HIGHWAY WORK PROPOSAL

<u>COUNTY</u>	<u>STATE PROJECT</u>	<u>FEDERAL</u>	<u>PROJECT DESCRIPTION</u>	<u>HIGHWAY</u>
Waupaca	6843-00-72	N/A	Waushara Co Line - Waupaca; Waupaca County Salt Shed	CTH A

Addendum No. 01
ID 6843-00-72
Revised Sheet 3
January 6, 2020

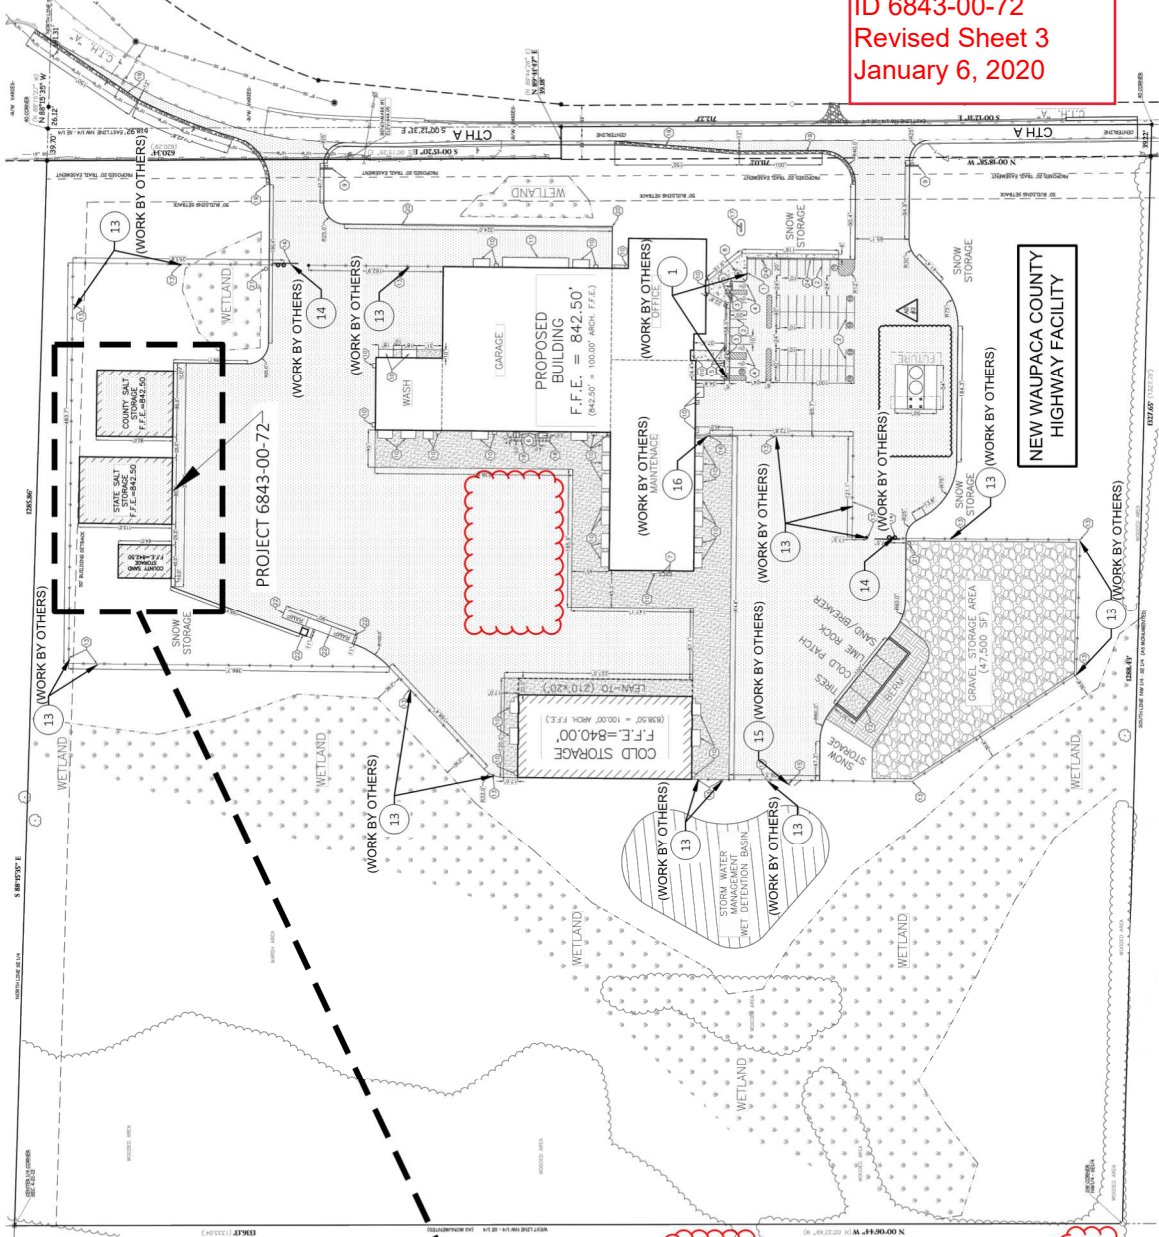
Revised Plan Sheets	
Plan Sheet	Plan Sheet Title (brief description of changes to sheet)
3	Removed legend note 18, concrete bollard (work by others) and site plan note 18 (work by others). Revised note under location of state salt storage to match building floor detail (sheet 4) and pavement detail (sheet 5) and removed (by owner) from 5" asphaltic surface.
